ARCHITECTURAL REVIEW BOARD STAFF REPORT

Project #/Name	ARB-2021-63: Shentel (Beam) Fixed Wireless – 50064 Patterson Mill – Tier 2 PWSF
Review Type	Preliminary Review of a Site Development Plan
Parcel Identification	07100-00-00-037J0
Location	North side of Patterson Mill Lane, just south of I-64 (See Figure 1.)
Zoned	Rural Area (RA) / Entrance Corridor (EC)
Owner/Applicant	Patricia W. Patterson / Shentel (Jessie Wilmer)
Magisterial District	Samuel Miller
Proposal	To construct a telecommunications facility consisting of a 98.5’ monopole tower and associated structures and equipment.
Context	The immediate area is wooded and adjacent to Interstate 64. The surrounding area is rural in character with residential and agricultural buildings.
Visibility	See page 3.
ARB Meeting Date	July 6, 2021
Staff Contact	Khris Taggart

Figure 3: Applicant's photo simulation of the existing monopole and proposed monopole from I-64 eastbound looking south.

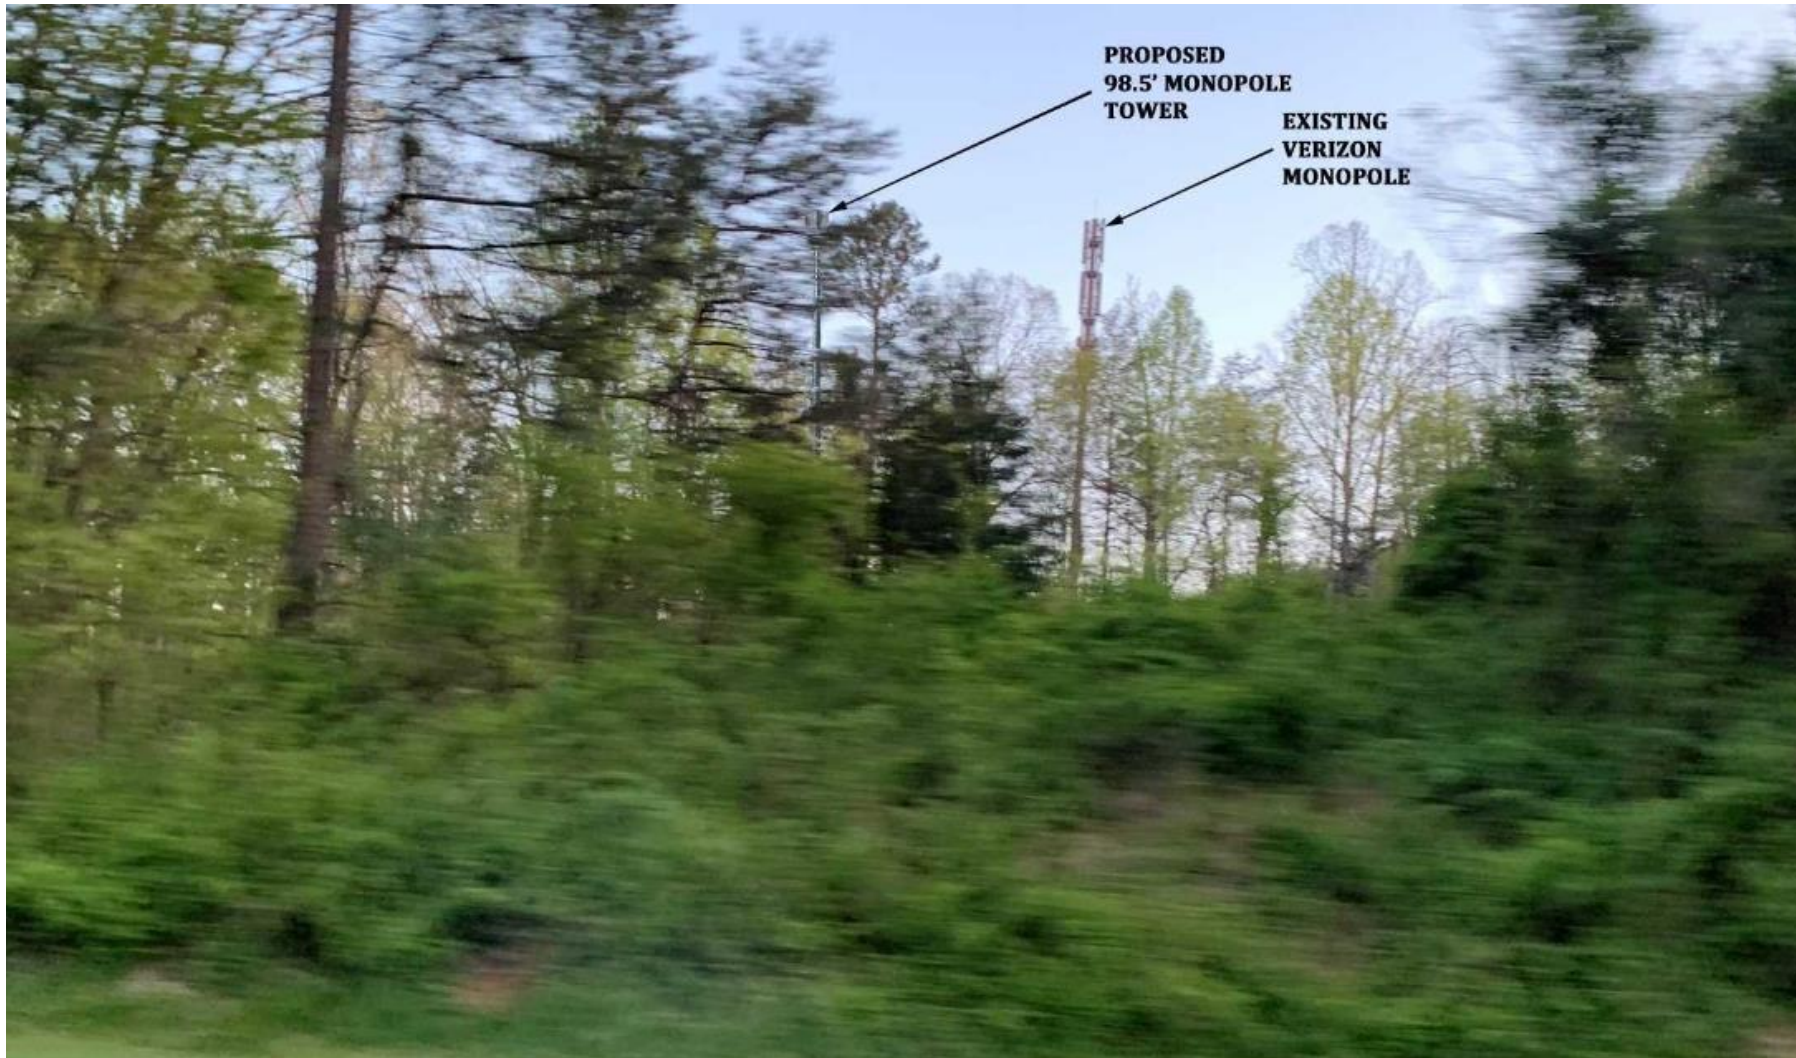
Ref	Guideline	Issues	Recommendations
	Development pattern		
33	The relationship of buildings and other structures to the Entrance Corridor street and to other development within the corridor should be as follows: f. The placement of structures on the site should respect existing views and vistas on and around the site.	The site visit in late June revealed that the existing monopole was not visible from either the eastbound or westbound lanes of I-64. There is a slight increase in visibility during the months when the leaves are off the trees, as evidenced by the applicant’s photo simulations that appear to have been taken in Spring. (See Figures 2-5.) These images show that the existing pole is visible through the trees from vantage points on I-64 directly across from the site, and rising slightly above the trees from a more distant point on the corridor. Note, however, that the existing pole is not skylit. With a location and height similar to that of the existing monopole, the proposed monopole is expected to have the same level of visibility.	Given the degree of visibility when viewing the existing site, the proposed location of the new facility is expected to sufficiently minimize the visibility of the monopole from the I-64 EC. Little to no negative impact on the Entrance Corridor is anticipated.

1. The ARB finds that the proposed location will sufficiently minimize the visibility of the monopole from the I-64 Entrance Corridor.
